## SCAPPOOSE PLANNING COMMISSION

##### 5.1 Docket #SDR 2-23

**CITY OF SCAPPOOSE  
PLANNING COMMISSION STAFF REPORT**

**Request:** Approval of an application for Site Development Review to allow for the change of use from an existing single-family home to a real estate office as well as improvements to various site amenities.

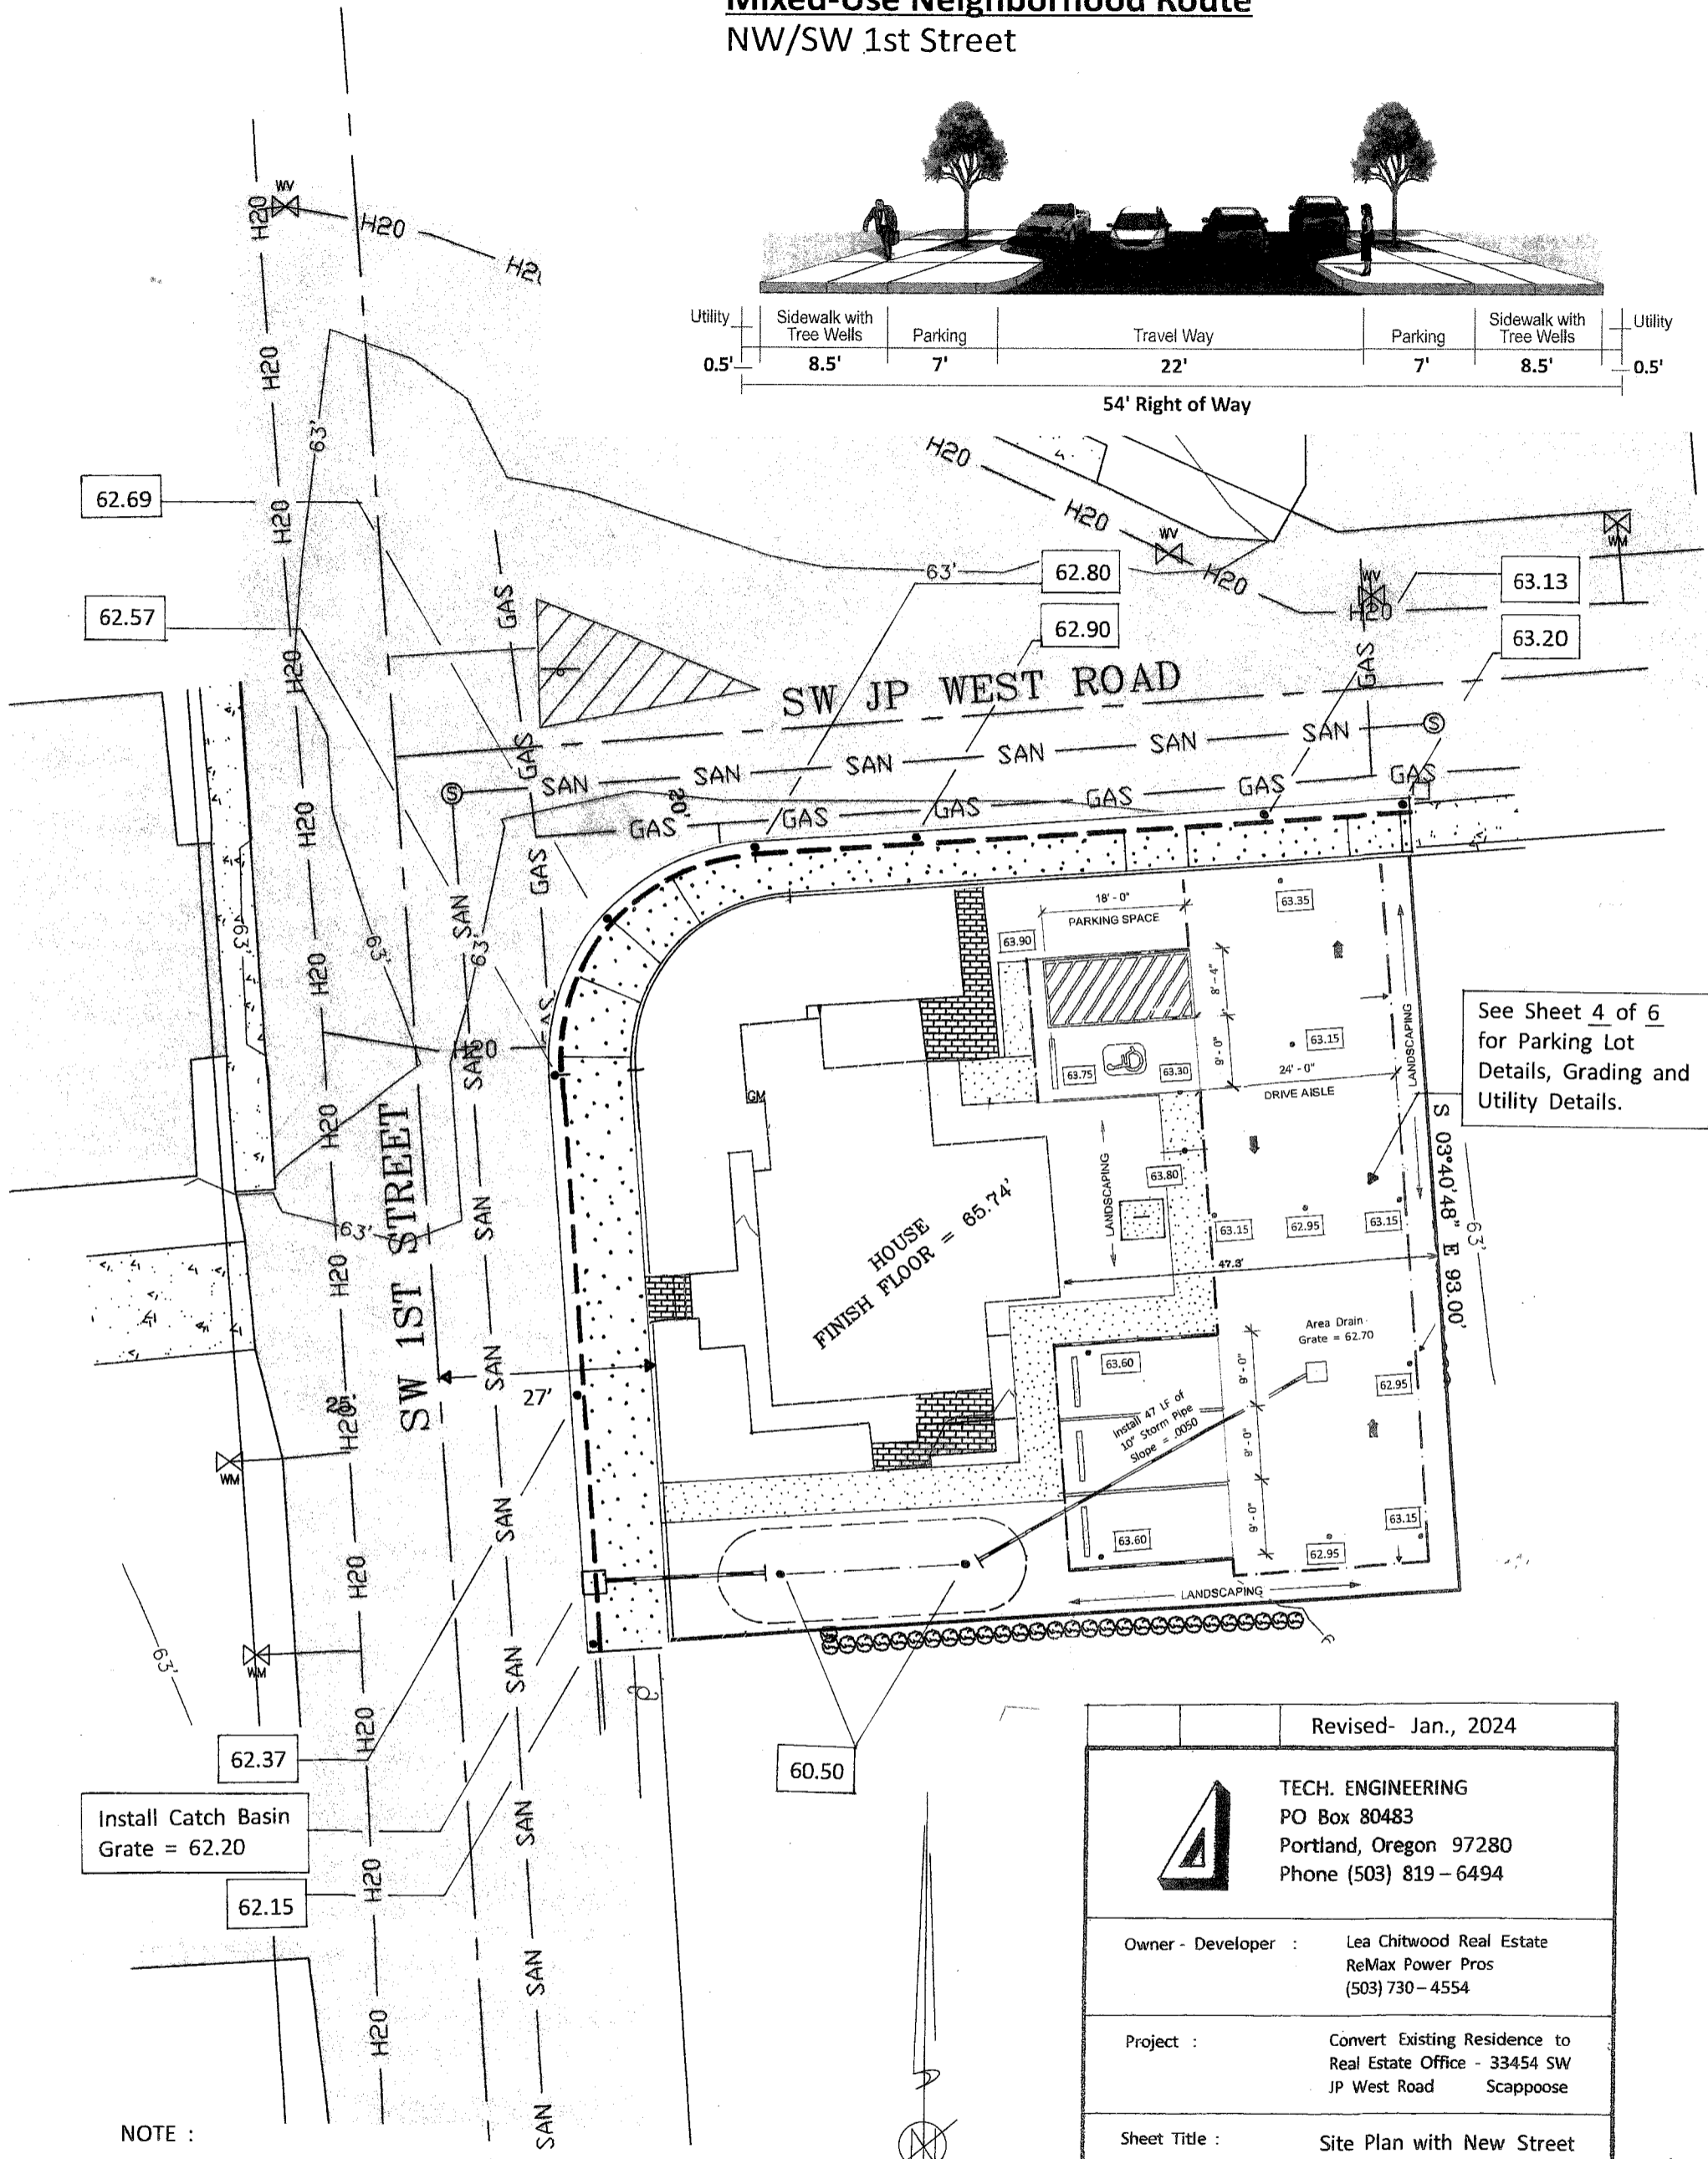
**Finding:** The applicant is proposing to install a walkway system that allow pedestrians to access the site and building from either sidewalk or any of the vehicular parking spaces (see **Exhibit 4C**). The walkway paths are proposed to be constructed with either brick or concrete, distinguishing them from the parking lot (see **Exhibit 4C**). The applicant will be required by the recommended Conditions of Approval to provide sufficient on-site lighting. The pathways are also as short and convenient as possible (see **Exhibit 4C**). Section 17.80.050(C)(5) is satisfied.

**Finding:** The applicant proposes to provide a continuous pedestrian walkway system that connects the sidewalks (to be constructed as part of this development), the building entrance, and the parking lot (see **Exhibits 4C & 4D**). The walkway system is safe, efficient, and incorporates all necessary areas of the site. The walkway system is not proposed on both sides of the drive aisle (see **Exhibit 4D**) so no crosswalk will be required. As a commercially zoned property, the applicant will be required by the recommended Conditions of Approval for the on-site walkway system to be 6-foot-wide and to be constructed of concrete. Section 17.120.180(Q) is satisfied.

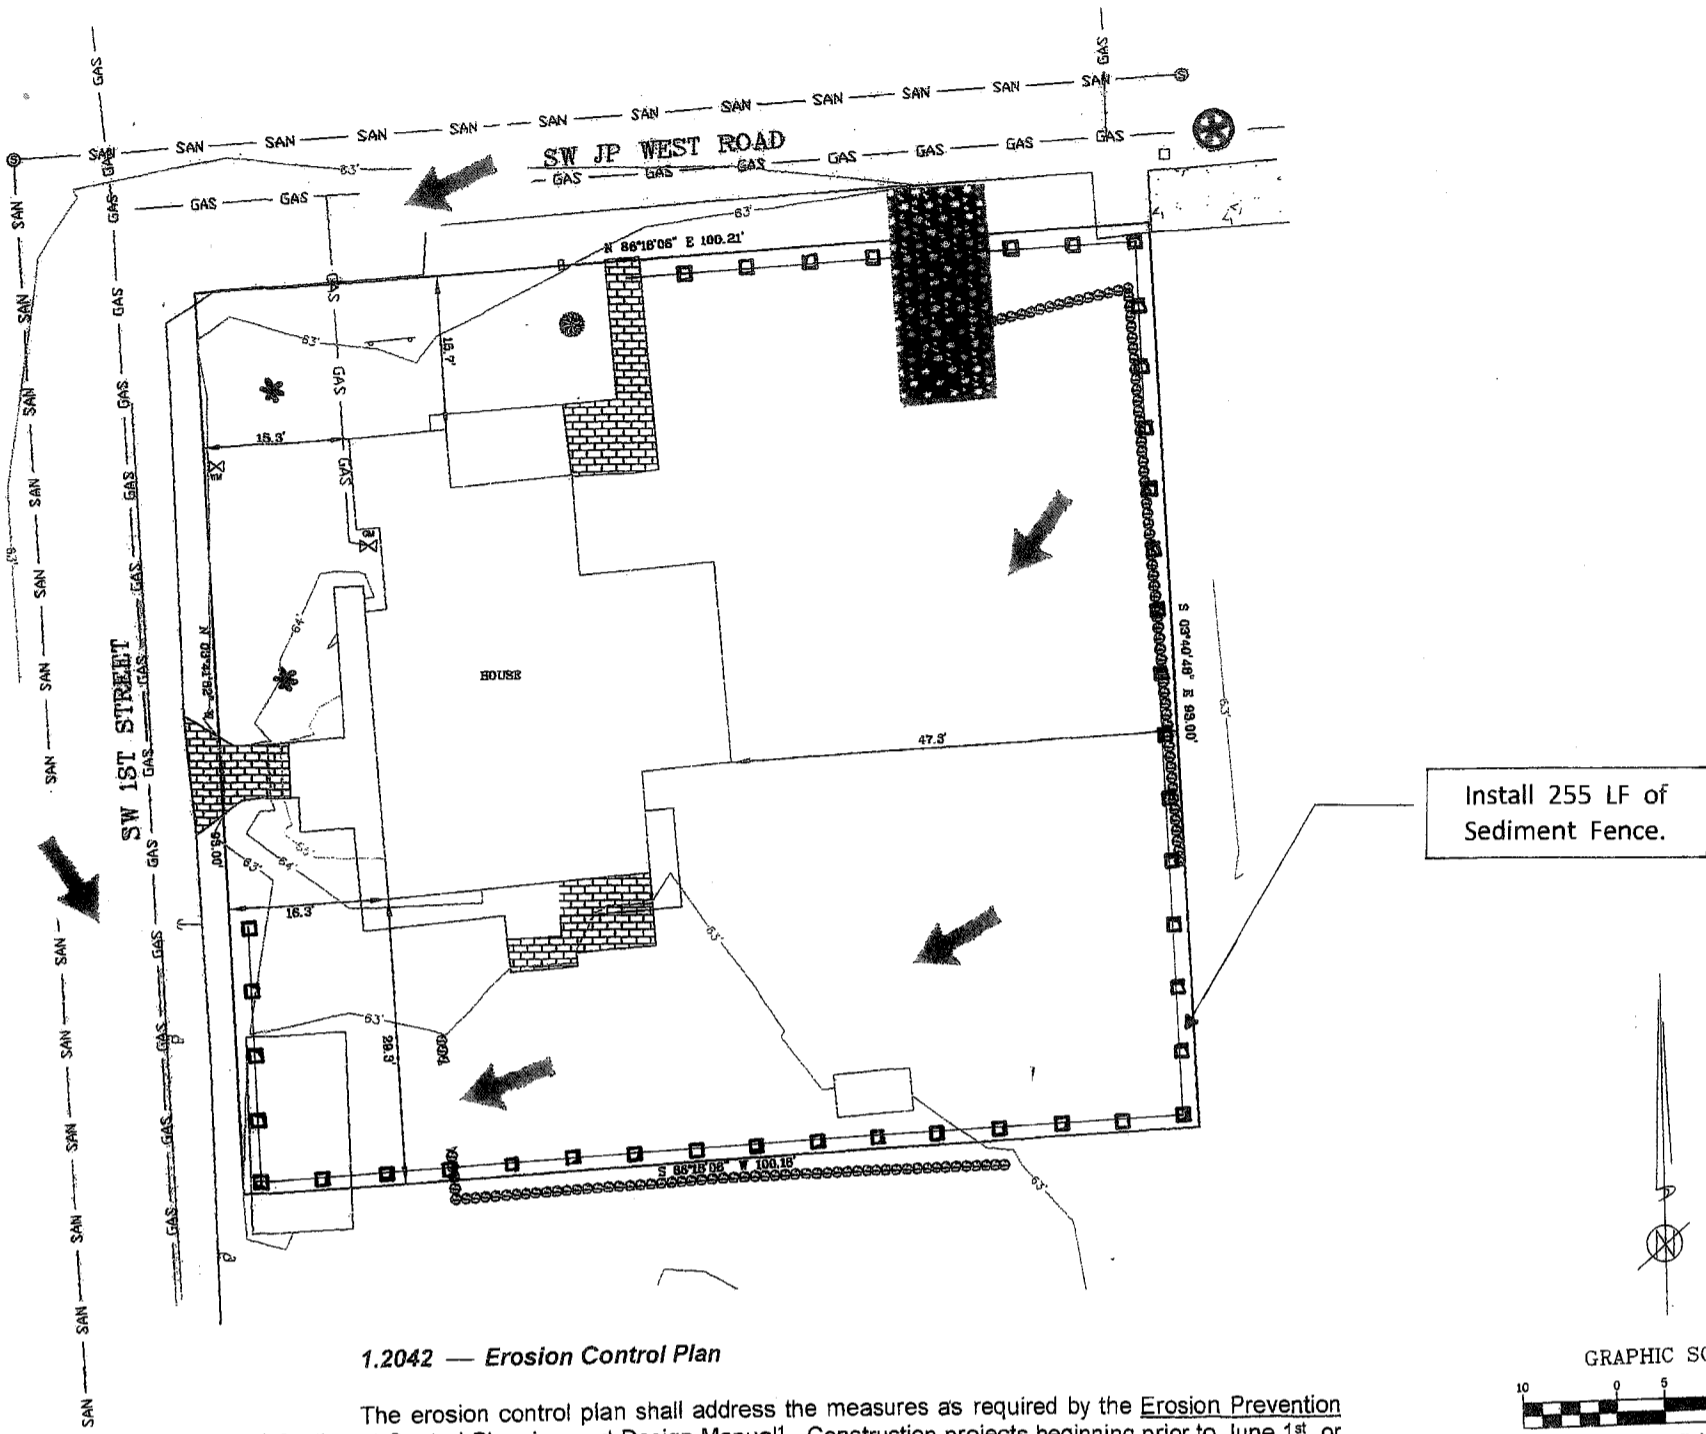
**Finding:** The applicant is proposing for all parking spaces to be 90° from the curb (see **Exhibit 4D**). All parking spaces are 9 feet wide, 18 feet deep, provide an aisle width of 24 feet, and a curb length of 9 feet (see **Exhibit 4D**). Section 17.106.050(B) is satisfied.

**Finding:** The applicant is proposing the installation of a 20-foot-wide commercial driveway to connect SW JP West Road to a 24-foot-wide drive aisle on the site, which would ultimately provide access to the provided parking spaces (see **Exhibit 4D**). Section 17.106.050(G)(1) is satisfied.

**Finding:** The applicant has submitted a Parking Lot Details, Grading and Utility Plan (**Exhibit 4D**), which illustrates the preliminary drainage plan, as part their application. The City of Scappoose Public Works Director provided a referral comment (**Exhibit 8**) stating that they have no objection to this application's approval as submitted provided it meets all criteria set forth in the Scappoose Municipal Codes, PWDS, and Building/Plumbing Codes. The applicant will submit final drainage plans to the Public Works Director and City Engineer for review and approval. Section 17.120.180(N) is satisfied.

**Finding:** The applicant is proposing to install an area drain grate in the middle of the parking lot for stormwater to be conveyed into an on-site infiltration facility via a new 10-inch stormwater pipe (see **Exhibit 4D**). The Public Works Director provided a referral comment (**Exhibit 8**) stating that they have no objection to this application's approval as submitted provided it meets all criteria set forth in the Scappoose Municipal Codes, PWDS, and Building/Plumbing Codes. Section 17.154.100 is satisfied.

19. The applicant shall install an area drain grate in the middle of the parking lot for stormwater to be conveyed into an on-site infiltration facility via a new 10-inch stormwater pipe, as depicted in the Parking Lot Details, Grading and Utility Plan (**Exhibit 4D**).
